**TWO-PIECE OIL CONTROL RING
ELECTRA-GLIDE AND SPORTSTER MODELS**

HARLEY-DAVIDSON MOTOR CO.

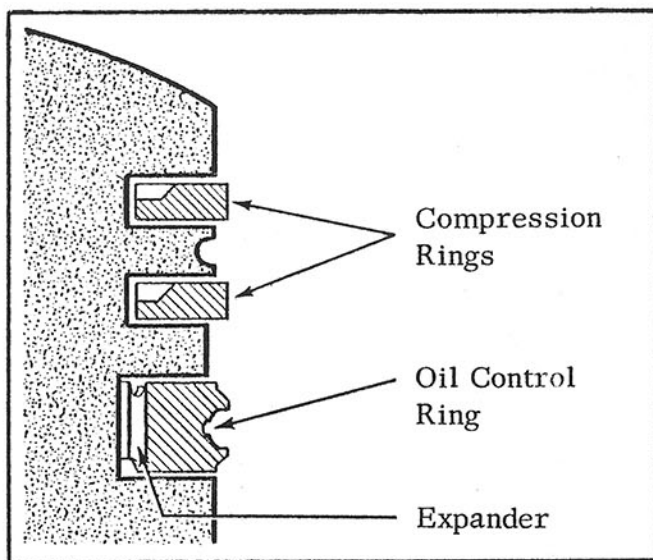
A two-piece oil control ring has been in use on the Sportster and Electra-Glide engine since the start of the 1966 model season.

This ring for the lower piston ring groove consists of a ventilated cast iron double edged scraper ring with a separate expander spring behind it.

The new two-piece oil ring is now included in all standard and oversize piston ring sets and piston assemblies supplied for parts orders.

Part numbers for these assemblies have not changed.

Rail type oil control rings will no longer be supplied.
